REMARKS

Dong-Ho LEE
 STACK PACKAGE MADE OF CHIP SCALE PACKAGES
 Attorney Docket No. 9903-074/Application No. 10/750,979

Annotated Sheet Showing Changes

FIG. 4

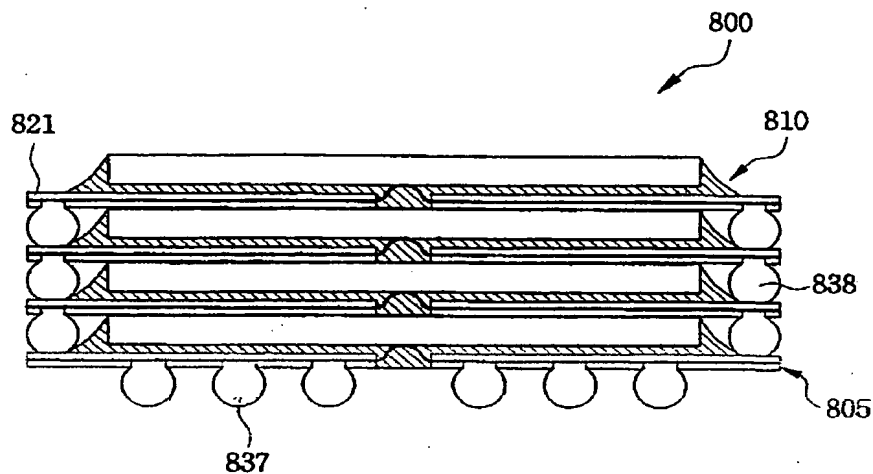
The drawings are objected to as failing to comply with 37 CFR 1.84(p)(5) because they include the following reference characters not mentioned in the description: 821 and 838 of FIG. 3, 151-152, 167, 171, 175, 183 of FIG. 4.

The drawings are objected to because in FIG. 4 the character '111' should be showing the IC and not the substrate.

The specification has been amended to properly identify the reference characters in FIGS. 3 and 4.

FIG. 4 has been amended to correctly connect the reference character '111' to the IC and not the substrate. The amended replacement sheet is enclosed in the Appendix following page 11 of this paper.

FIG. 4 is amended to correctly connect reference number 111 to the lower semiconductor chip. An annotated sheet showing changes and replacement sheet are enclosed in the Appendix following page 10 of this paper.
